Re: Notice of Final Determination of Compliance (FDOC)
Facility: Lodi Energy Center (08-AFC-10)
Project Number: N-1083490

Re: Notice of Final Determination of Compliance (FDOC)
Facility: Lodi Energy Center (08-AFC-10)
Project Number: N-1083490

NOTICE IS HEREBY GIVEN that the San Joaquin Valley Unified Air Pollution Control District has issued a Final Determination of Compliance (FDOC) to Northern California Power Agency (Lodi Energy Center) for a 294 MW (nominal), natural gas-fired, combined-cycle, electric generation facility that will consist of a Siemens natural gas-fired STG6-500F "Flex Plant 30" combustion turbine generator equipped with dry-low NOx combustors, an unfired heat recovery steam generator, a steam turbine generator, a seven-cell mechanical draft cooling tower system equipped with high efficiency drift eliminators, and a natural gas-fired auxiliary boiler, all located at 12745 North Thornton Road in Lodi, CA.

Comment #4:

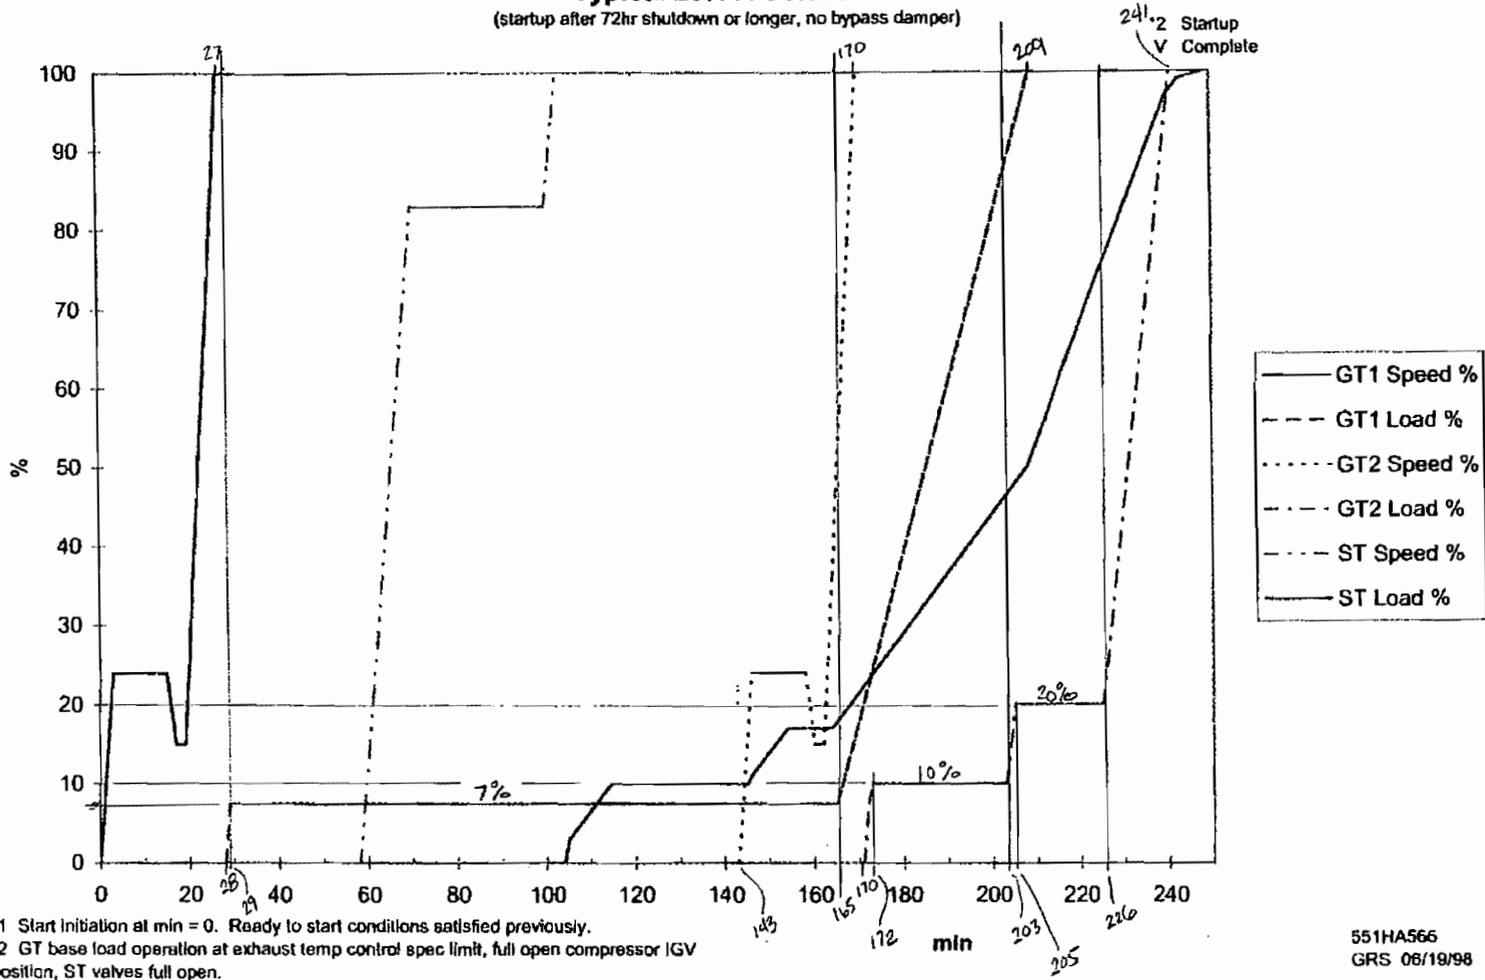
Energy Commission staff appreciates the explanation of the interpollutant offset ratio provided in the PDOC Attachment G. The modeling for the interpollutant ratio is part of the 2008 PM2.5 Plan that was adopted by ARB on May 22, 2008, and the plan was subsequently submitted to U.S. EPA. However, as of late April, 2009, there had been no U.S. EPA action on the PM2.5 plan.

- Please describe whether the development of the interpollutant ratio has been reviewed and/or approved by U.S. EPA.

Response:
